Urgent Field Safety Notice Molecular Diagnostics at Abbott Product: Alinity m System List Numbers: 08N53-002

March 19, 2024

Urgent Field Safety Notice Molecular Diagnostics at Abbott Product: Alinity m System

Appendix A

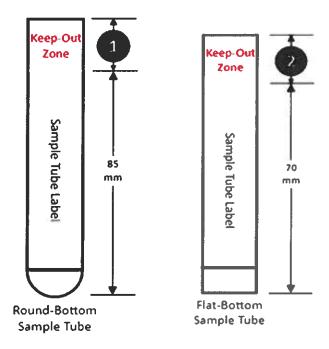
The Alinity m System camera detects whether tubes are "capped." If the camera detects a cap and the retention bar is not present on the sample rack, the system will generate the message "Error – 6013: Has cap, no retention bar." Any color other than black or white within the Keep-Out Zone (See Appendix A) on the tube label can cause the camera to falsely detect a cap, resulting in generation of the error code. Because this is an incorrectly generated error code, the corrective action associated with Message Code: 6013 of "Remove sample rack and add the retention bar with the rack" will not remediate the issue. The correct method to remediate this error code is outlined in the Necessary Actions section of this letter.

Aliquot the sample from the sample tube that is experiencing the error to a different sample tube, as permitted by the assay package insert, and ensure the following sample tube label requirements are met:

- 1. This area defined as is the keep-out zone for the round-bottom sample tube. The keep-out zone is the area where the sample tube label cannot contain colors other than white and black, above a maximum of 85 mm from the bottom of the tube.
- 2. The area defined as 2 is the keep-out zone for the flat-bottom sample tube. The keep-out zone is the area where the sample tube label cannot contain colors other than white and black, above a maximum of 70 mm from the bottom of the tube.

1. Aliquot the sample into another tube permitted by the assay package insert and ensure the sample tube label requirements in Appendix A are met.

2. Cover colored portion of tube label that is present in the Keep-Out Zone, depicted in Appendix A, with white opaque material (e.g. white sticker) where the barcode is located. Avoid covering any needed sample information when applying an additional sticker to the sample tube.
